## Proposal for draft 01 series of amendments to Regulation No. 120

Uniform provisions concerning the approval of internal combustion engines to be installed in agricultural and forestry tractors and in non-road mobile machinery, with regard to the measurement of the net power, net torque and specific fuel consumption

Note: The aim of this proposal is to amend Regulation No. 120 in order to align the provisions of this Regulation with those of gtr No. 11 and Regulation No. 96.

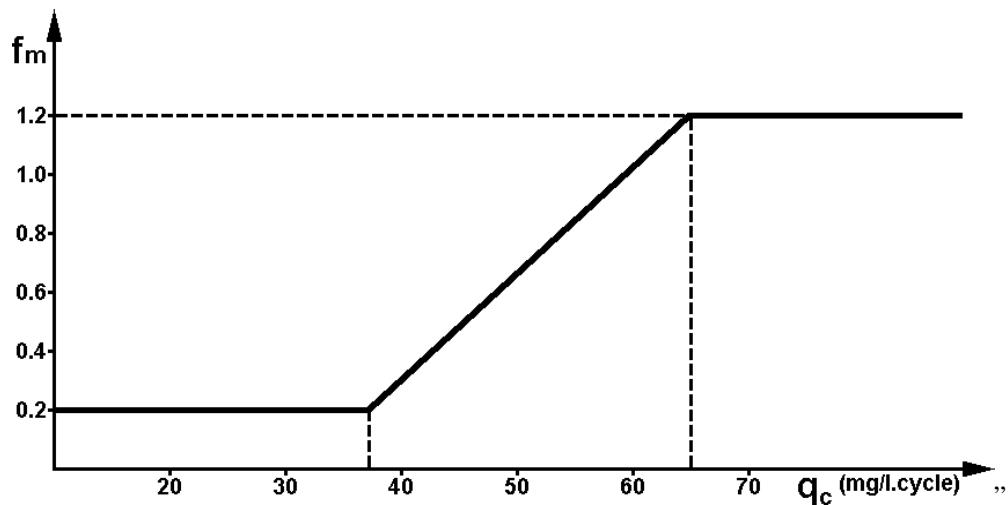
Annex 4, Paragraph 5.4.2.2., amend to read:

“5.4.2.2. Engine factor  $f_m$

$f_m$  is a function of  $q_c$  (fuel flow corrected) as follows:

$$f_m = 0.036 q_c - 1.14$$

$$q_c = q/r$$

$r$  is the pressure ratio of compressor outlet and compressor inlet **in case of multiple turbochargers  $r$  represents the total compression ratio** ( $r = 1$  for naturally aspirated engines)

This formula is valid for a value interval of  $q_c$  included between 37.2 mg/(l.cycle) and 65 mg/(l.cycle).

For  $q_c$  values lower than 37.2 mg/(l.cycle), a constant value of  $f_m$  equal to 0.2 ( $f_m = 0.2$ ) will be taken.

For  $q_c$  values higher than 65 mg/(l.cycle), a constant value of  $f_m$  equal to 1.2 ( $f_m = 1.2$ ) will be taken (see figure):
